TITLE/SUBJECT:  
Emergency Service Water System Pump Shaft Coupling Failure Analysis

EA-254

Comments on Structural Integrity Stress Analysis  
File N. PERY-03Q-301

# Comments on Fracture Analysis of a Normal Coupling

Pump Shaft Dimensions0001

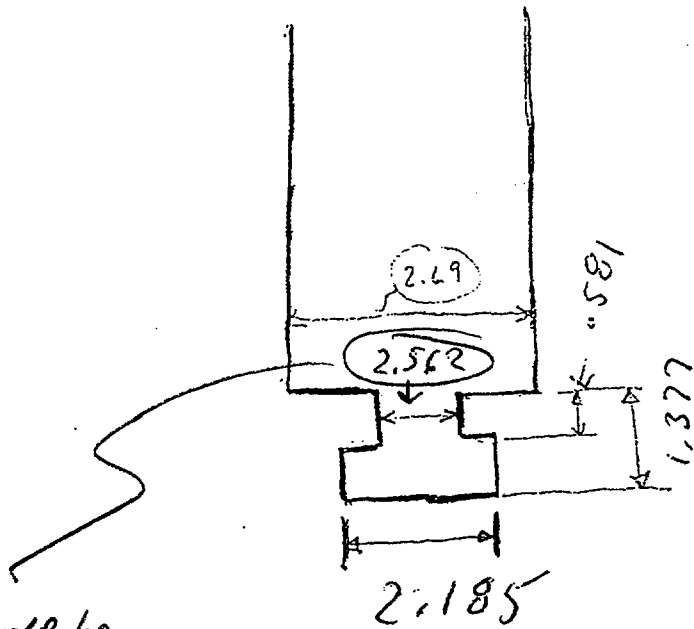
There is a revision to the attached dimensions. The necked down region should be 1.562 **not** 2.562 as shown in the sketch.

Should be  
1.562 per  
M. BAY

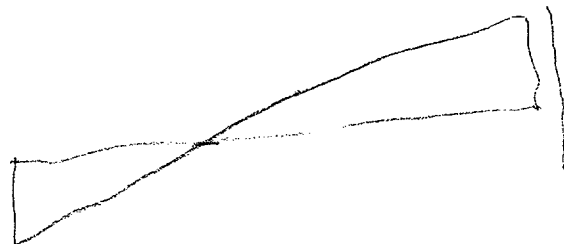
What is the orientation of local and global coordinate system in the model?  $S_1 - 59,000 + 96,000$   
 $S_2 - 63,000 + 33,000$

The key may be in the annealed condition will this impact the analysis?

Plots are based on cyl coord. Y is circ. hoop. "S<sub>1</sub>"  
Z is along axis "S<sub>2</sub>" up & down.  
X is Radial.

→ From failure report crack is opened by hoop (tangential stress)  
→ PRIA
